LAND USE DEPARTMENT | HISTORIC PRESERVATION DIVISION

ADMINISTRATIVE APPROVAL

Project Address: 511 Paseo de Peratta

**RE: Paseo North
511 Paseo de Peralta**

Proposed Exterior Light Fixture
10" wide X 18" tall

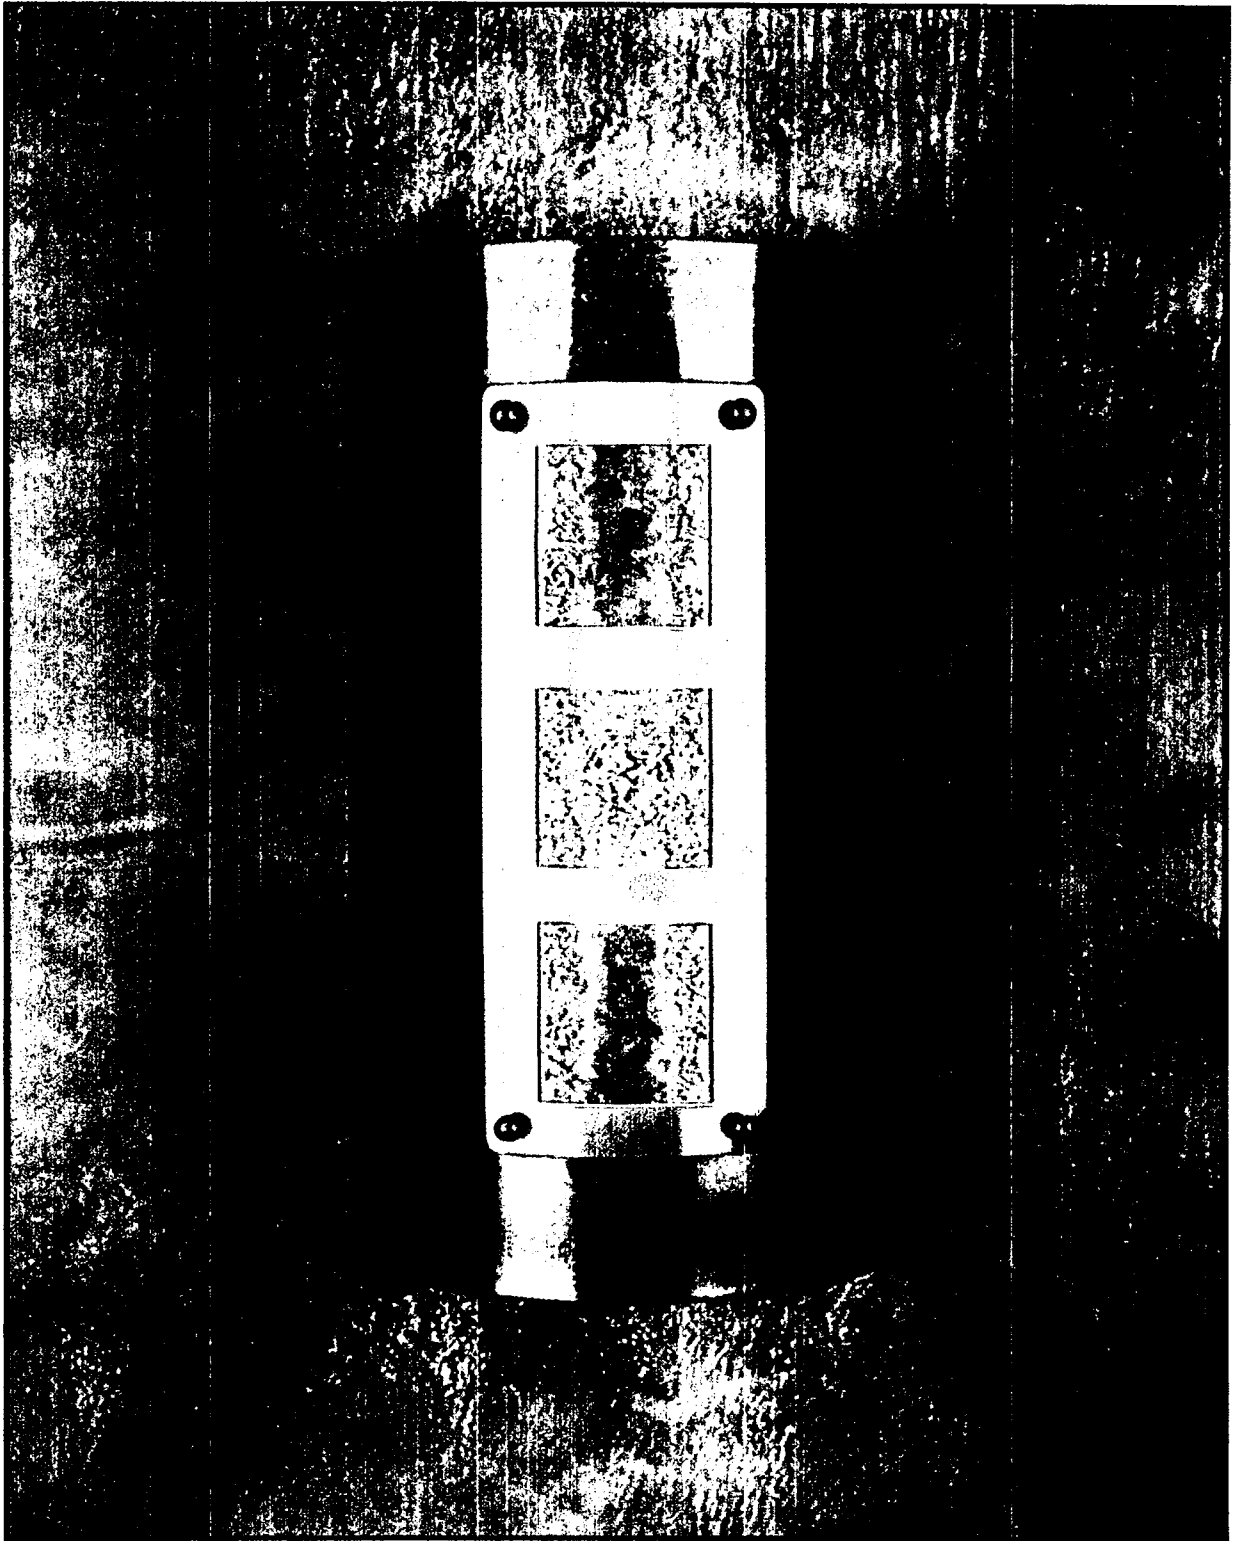
1. The proposed exterior light fixtures are shown on the plan. A photograph of the light fixture is attached to this letter.
